C1: Gate-SG
C2: CT-SG
C3: S-SG
C4: Load current

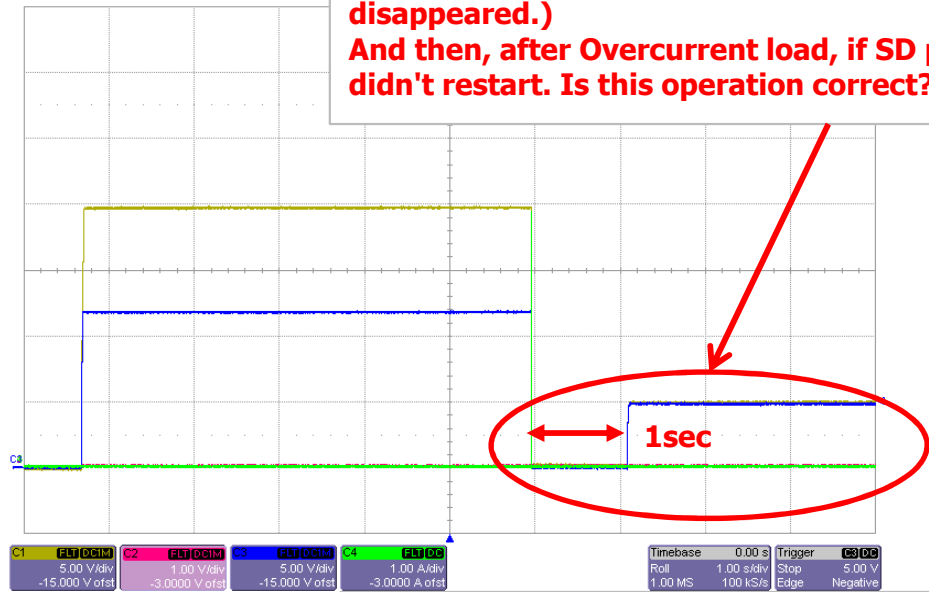
<Q1>
After Overcurrent load, the block diagram on the datasheet shows "output Latch-off".
However, after 1sec, the output restarted.
(this power was a little, if it was connected to the load, it disappeared.)
And then, after Overcurrent load, if SD pin set to low, the output didn't restart. Is this operation correct?

<Q2>
If SD pin set to low, is "Output Latch-off" released?
Furthermore, LR pin is added 6V.
